Re: Petition for Modifications No. 2, Walnut Creek Energy Park (05-AC-2C)

Petition for Modification No. 2

Transmission Structure Height Change

Walnut Creek Energy Park

FIGURE 2-1
WALNUT SUBSTATION
TIE-IN ALTERNATIVES
 WALNUT CREEK ENERGY PARK
 CITY OF INDUSTRY, CALIFORNIA

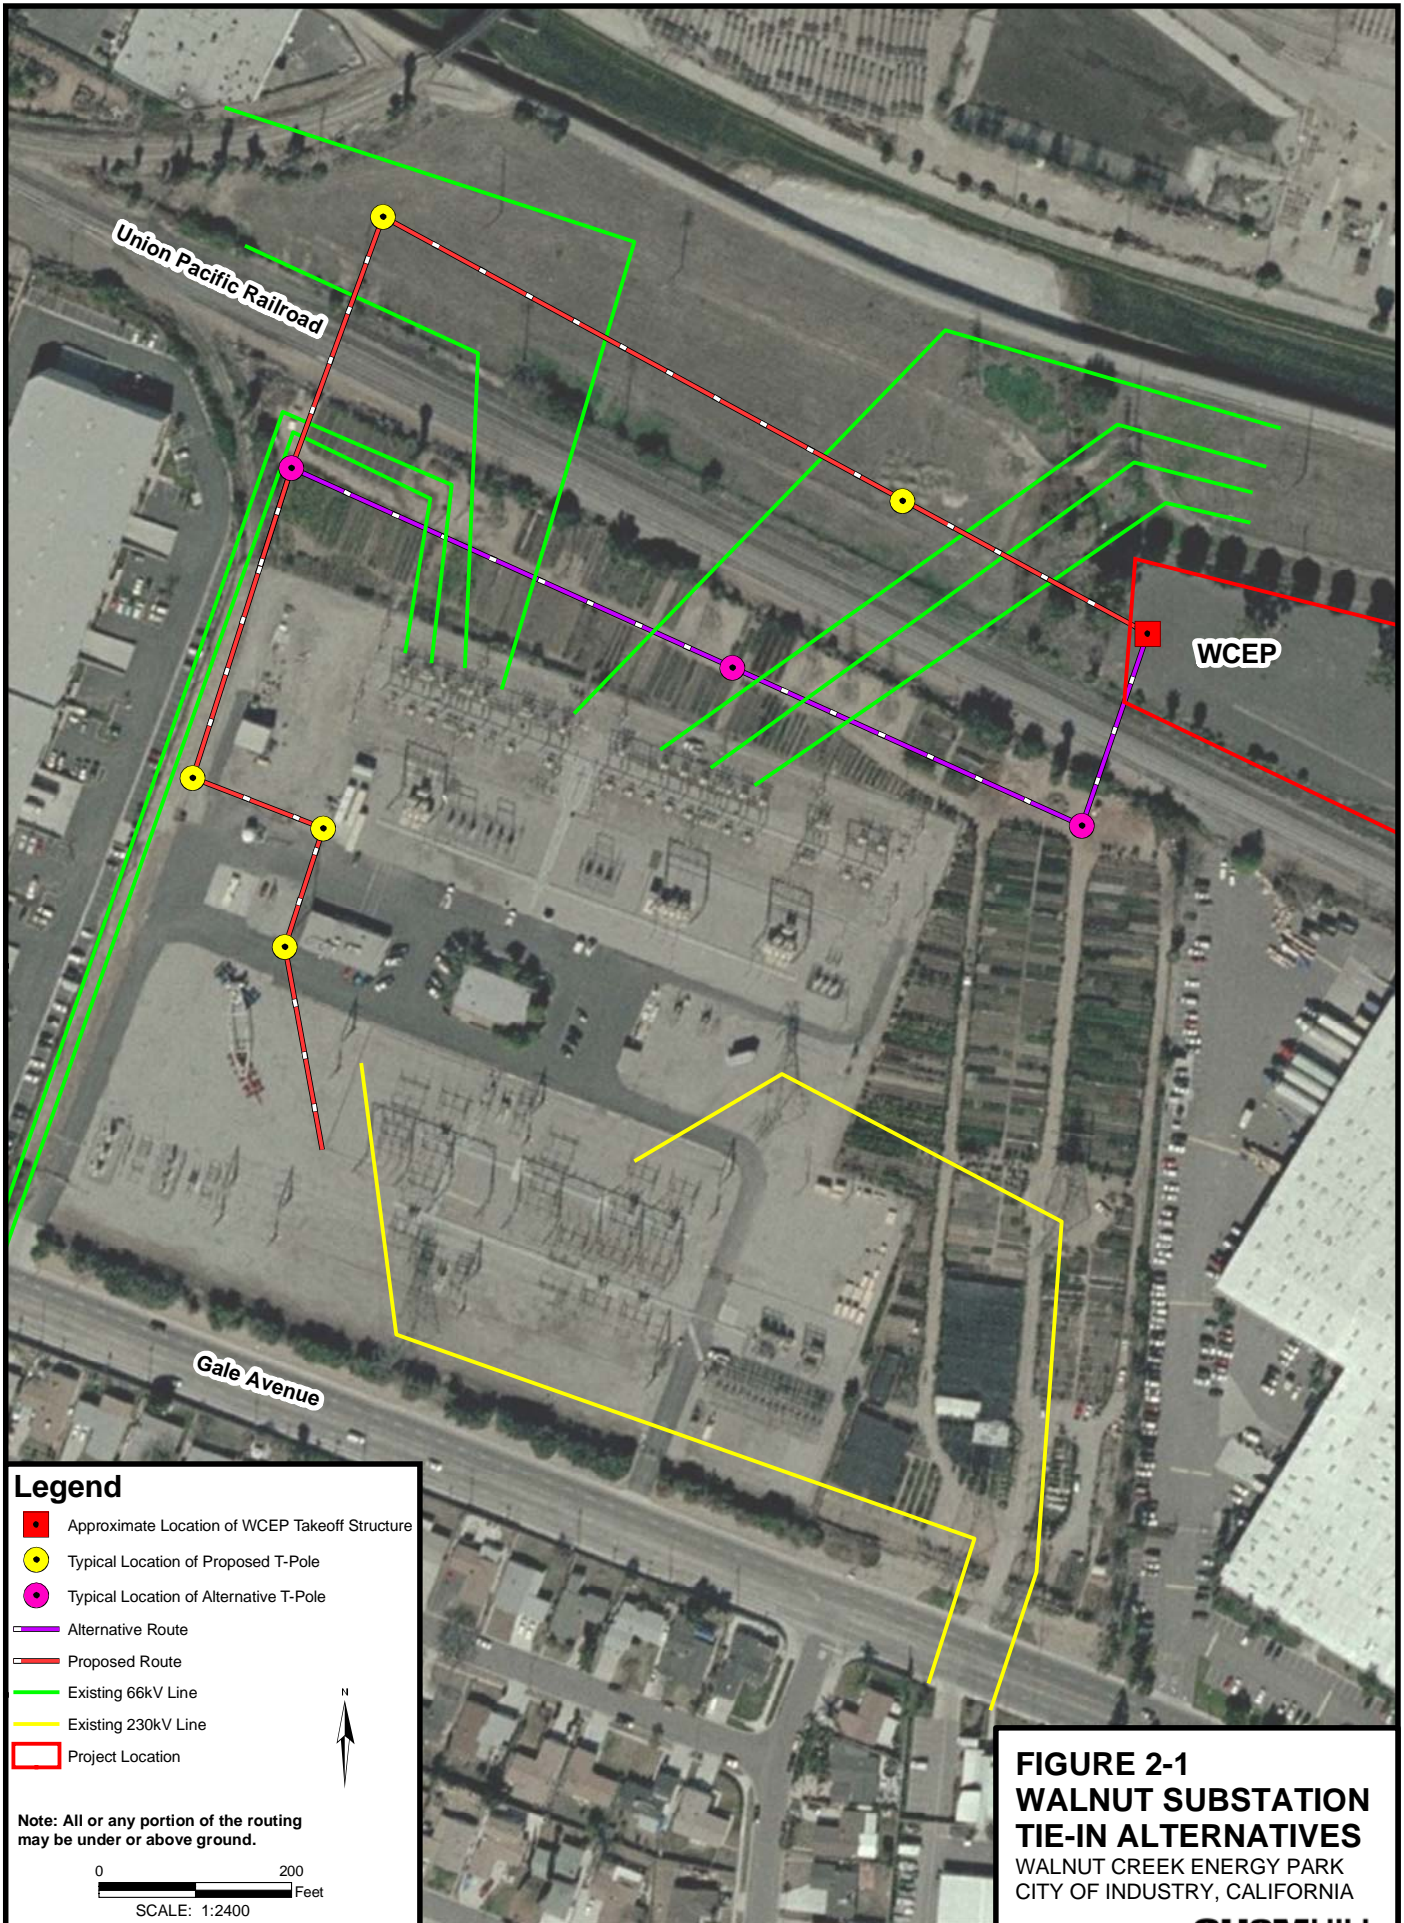
This Petition for Modification proposes to increase the height of the 5 proposed project generation tie-line structures from 90 feet tall to 115 to 135 feet tall. This would allow a safe distance between the conductors and towers of the existing 66-kV transmission lines and the WCEP's generation tie-line alignment in the event that SCE selects an overhead configuration as its preferred WCEP alignment.

This section includes a description of the proposed project modifications, consistent with CEC Siting Regulations (Title 20, CCR, Section 1769 [a][1][A]). WCE proposes to increase the height of the proposed transmission line structures that were described in the AFC and AFC Supplement IV to allow a safe distance between the existing 66-kV transmission lines' conductors and the proposed generation tie-line's conductors. The proposed structures would be a monopole design, as was described in the AFC, Section 5.0 Electric Transmission. Instead of being 90 feet tall, as described in that section and shown in AFC Figure 5.1-3, the proposed structures would be between 115 and 135 feet tall.

SCE will construct and own the generation tie-line from the WCEP site through the SCE ROW and Walnut Substation. Figure 2-1 shows the generation tie-line interface at the take-off structure on WCE property with 2 generation tie-line structures located in the SCE ROW and 3 structures located inside the Walnut Substation boundary. The green lines shown on Figure 2-1 are the 66-kV transmission lines with structures that would be shorter than the proposed transmission line structures. The yellow lines shown on Figure 2-1 are the 230-kV transmission lines with 150- to 170-foot-tall structures.
